PG&E Letter DCL-17-044  
PG&E Letter DIL-17-006

Docket No. 50-275, OL-DPR-80  
Docket No. 50-323, OL-DPR-82  
Diablo Canyon Units 1 and 2  
Docket No. 72-26, Materials License No. SNM-2511  
Diablo Canyon Independent Spent Fuel Storage Installation  
Emergency Plan Update for Appendix D Category H, Appendix F, Section 5, and Coversheet

**Diablo Canyon Power Plant Emergency Plan**

**Summary of the Analysis of Changes to Emergency Plan, Section 5**

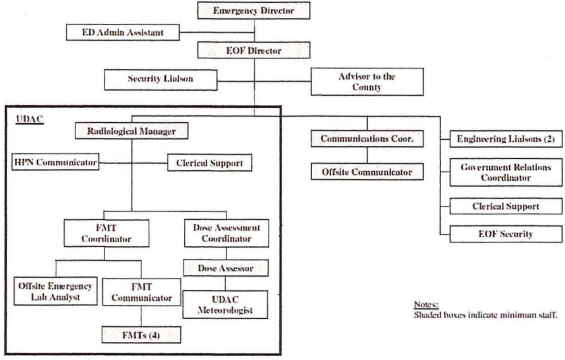
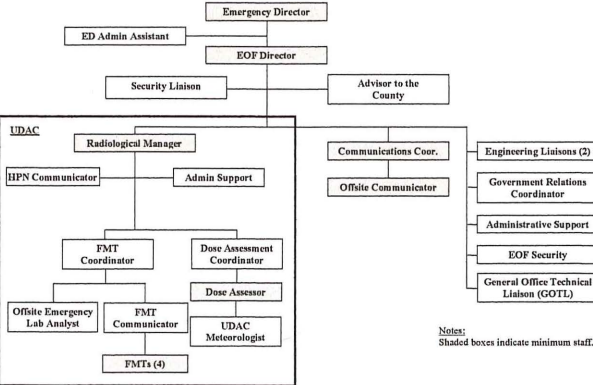
#	Original Content	Proposed Content	Reason for Change
	<p><b>Section 5.22, Figure 5-4, EOF Organization</b></p>  <p><i>Notes:</i> Shaded boxes indicate minimum staff.</p>	<p><b>Section 5.22, Figure 5-4, EOF Organization</b></p>  <p><i>Notes:</i> Shaded boxes indicate minimum staff.</p>	
6	<p><b>Section 5.9.7.1</b></p> <p>Operating the computer and projector system used to display graphics and other information during media briefings.</p>	<p><b>Section 5.9.7.1</b></p> <p>Operating the computer and display system used to project graphics and other information during media briefings.</p>	<p>Modified existing content.</p> <p>Section 5.9.7 is updated to reflect that the Joint Information Center (JIC) uses a display system, not a projector, to project graphics during media briefings.</p> <p>The JIC was recently updated with new equipment to enhance media briefing capabilities. Part of the update included replacing the projector with smart TVs that display graphics via a HDMI cable. These changes were made based on ERO feedback from multiple drills. Replacing “projector” with “display” aligns the E-Plan with EP EF-10, and the current process. This change was initially evaluated under 50.54(q) screening evaluation 2016-28. The projection/display functionality will still be provided and no ERO responsibilities are being assigned or removed. This change ensures that the E-Plan remains technically accurate.</p> <p><b>No additional evaluation necessary.</b></p>

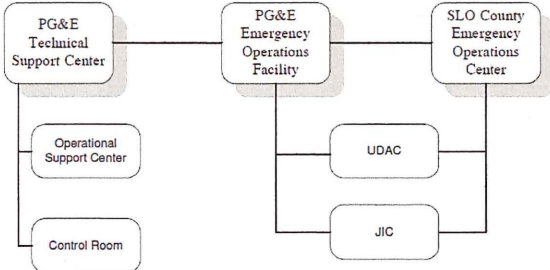
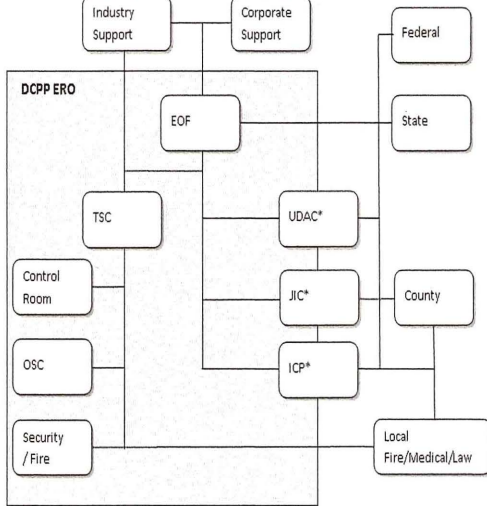
#	Original Content	Proposed Content	Reason for Change
7	<p>Section 5.10, Figure 1</p> 	<p>Section 5.10, Figure 1</p>  <p><small>* UDAC, JIC and ICP may be staffed by DCPPE, Federal, State and/or County personnel</small></p>	<p>Modified existing content.</p> <p>This change was identified during the EP licensing basis verification project and conformance review. This change updates a figure to better display the facility functional relationships between DCPPE ERO and offsite organizations. This revised figure more closely aligns with the SSER E-Plan Rev 3.03 and NUREG-0654 element B.6.</p> <p>NUREG-0654 element B.6 requires illustration of interface, and this change continues to meet this requirement. These relationships are defined in detail in other parts of section 5 of the E-Plan. Updating this figure does not alter the described interfaces.</p> <p><b>No additional evaluation necessary.</b></p>
